# SERVICE BULLETIN

DATE: 23 APRIL 2001

## NON-ROTATING SWASHPLATE ASSEMBLY BUSHING REWORK AND LONGITUDINAL DRIVE LINK ASSEMBLY INSPECTION AND REPAIR

**Figure 1. Swashplate Rework**

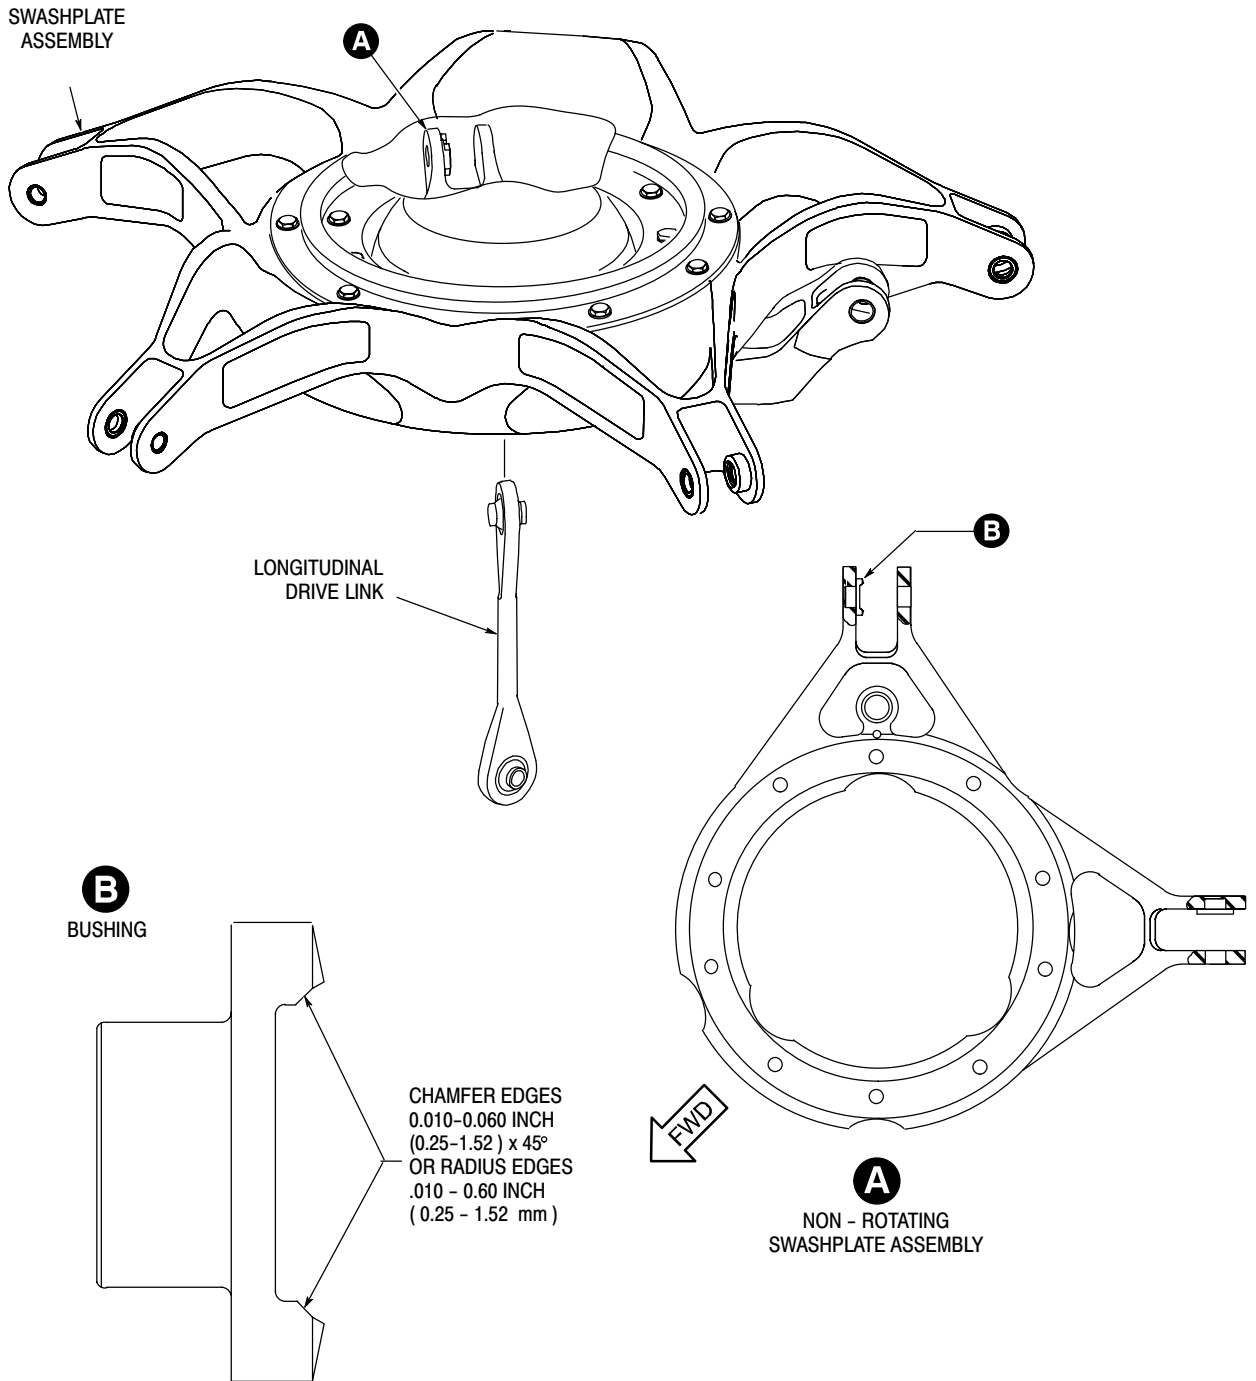
### **A. Rework non-rotating swashplate assembly:**

(Ref. Figure 1)

- (1). Remove longitudinal drive link assembly per instructions contained in the Rotorcraft Maintenance Manual (CSP-900RMM-2, Section 62-30-00).

**Figure 2. Repair of Longitudinal Drive Link**

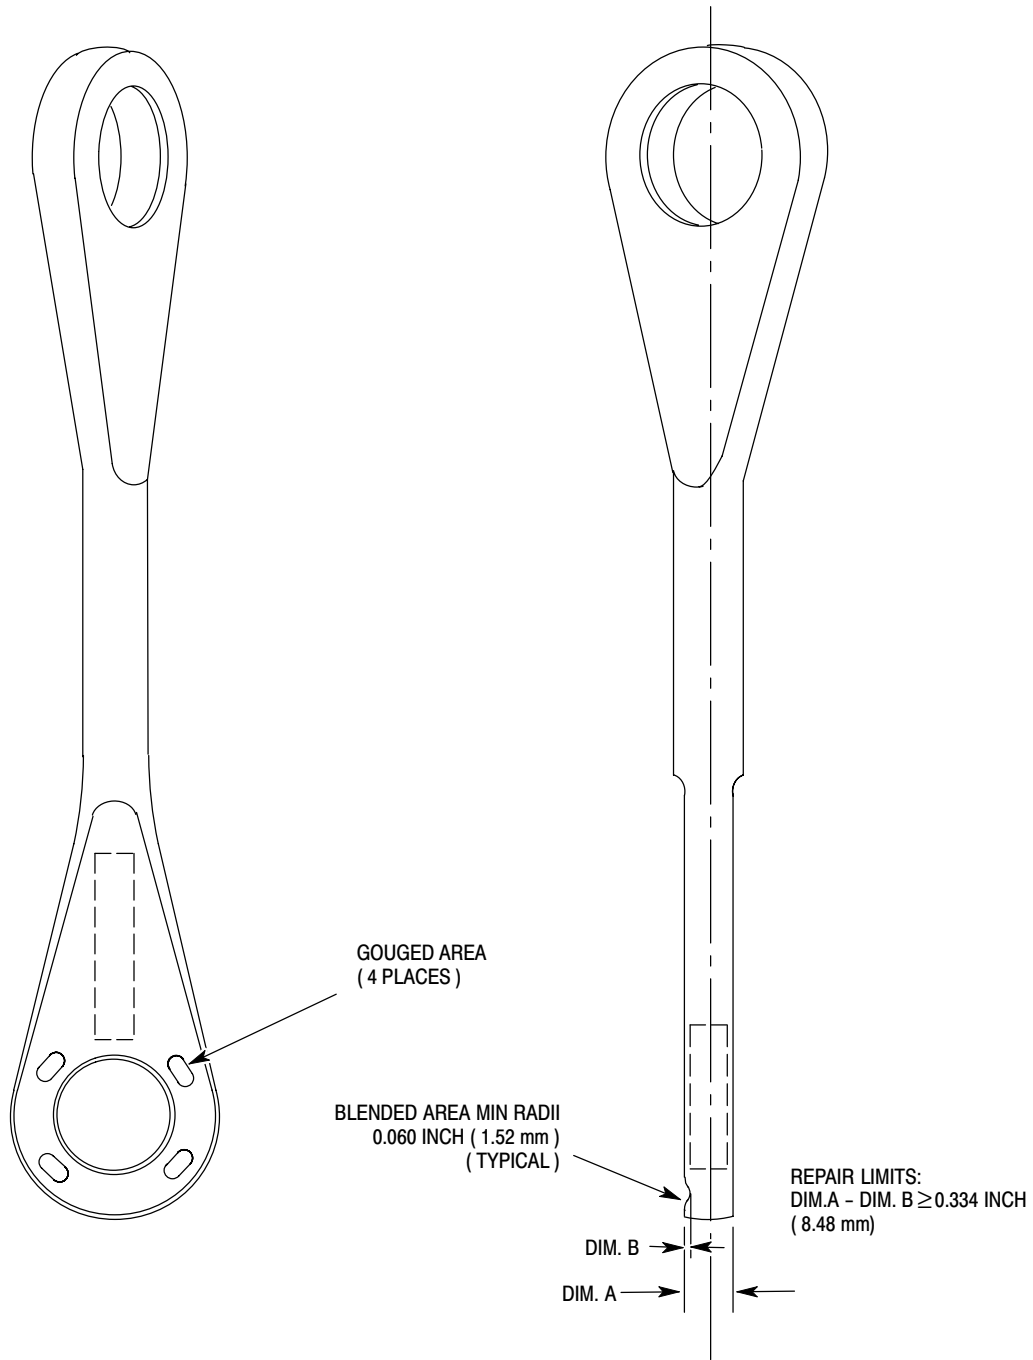
Procedures in this Bulletin provide owners and operators with information pertaining to rework of the bushing in the non-rotating swashplate assembly and inspection and repair of the longitudinal drive link assembly.
